1. In reference to project VA241-12-R-0313, the project scope of work states that we are to replace the (3) 500KVA transformers with new. We are to remove the existing transformers and document legal disposal of the units.

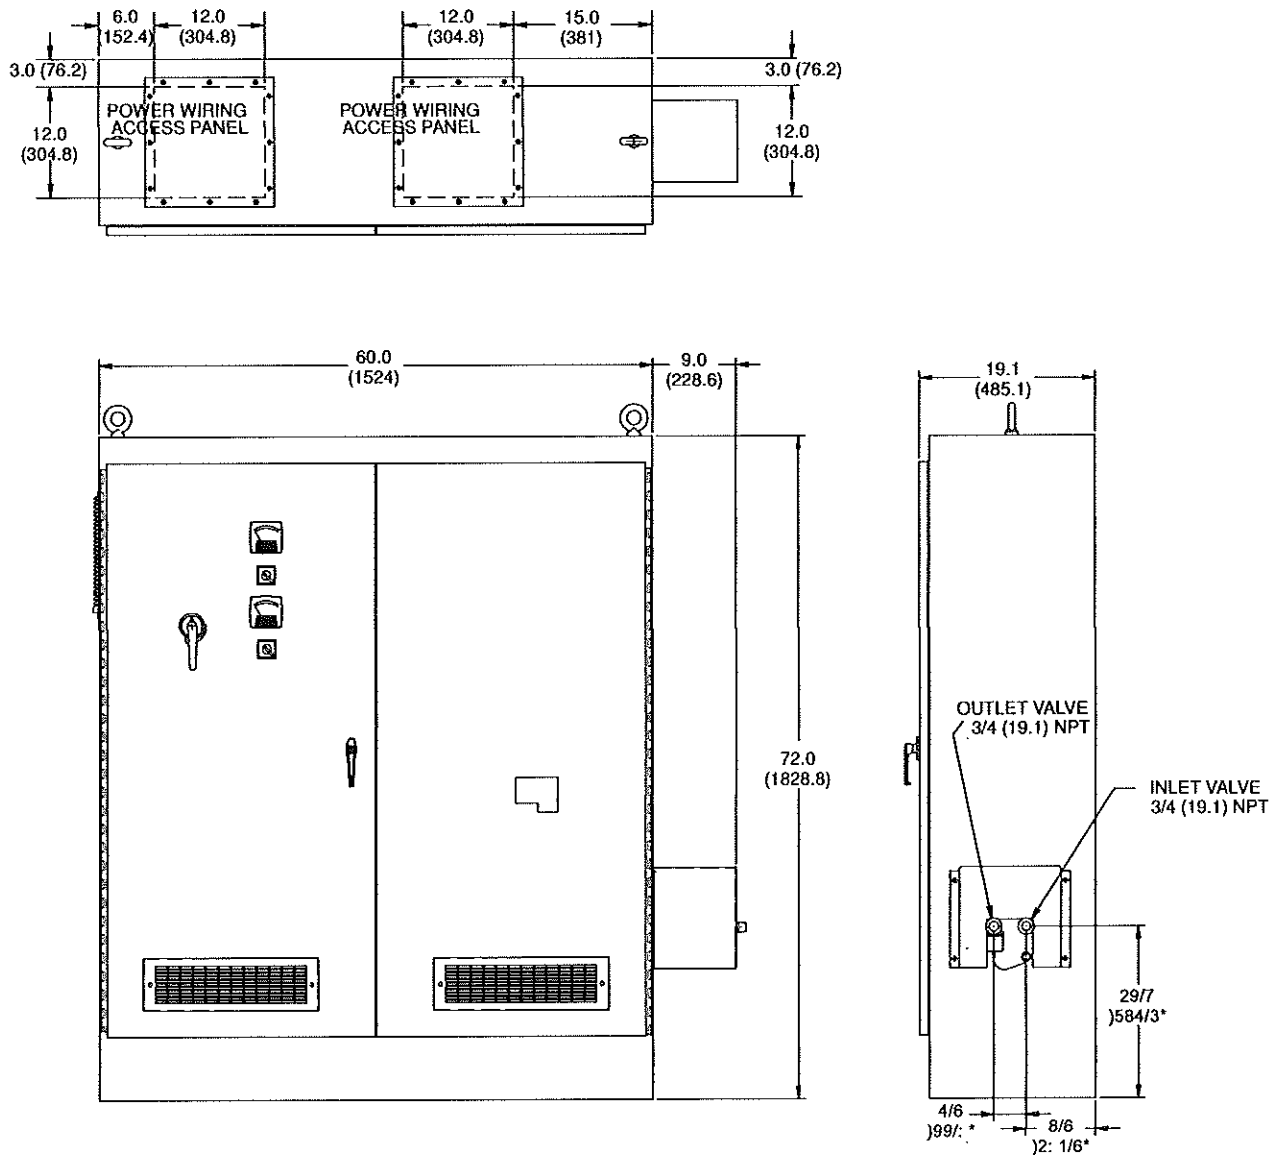
2. In order to size the transformer and the disconnect properly for this project, we need electrical information on the chiller. The impedance specifications are needed to help select the correct style of transformer. Also the Minimum Circuit Ampacity (MCA) is needed to size the transformer and fuses. Is this information available?

Please find attached the electrical requirements provided by McQuay of the chiller. The contractor shall provide the wire and conduits for drive power and controls from the starter to the VFD072LW new chiller. This work is being done through an awarded contract to McQuay International. The contact number is 203-775-3477.

This is a design build. The contractor's responsibility is to get the available fault current from the utility company (United Illuminating Co.) size the transformer with the lowest x/r ratio to provide low losses while keeping the available fault duty within the withstand value of the switch gear provided. A stamped coordination report is requested as part of the submittal.
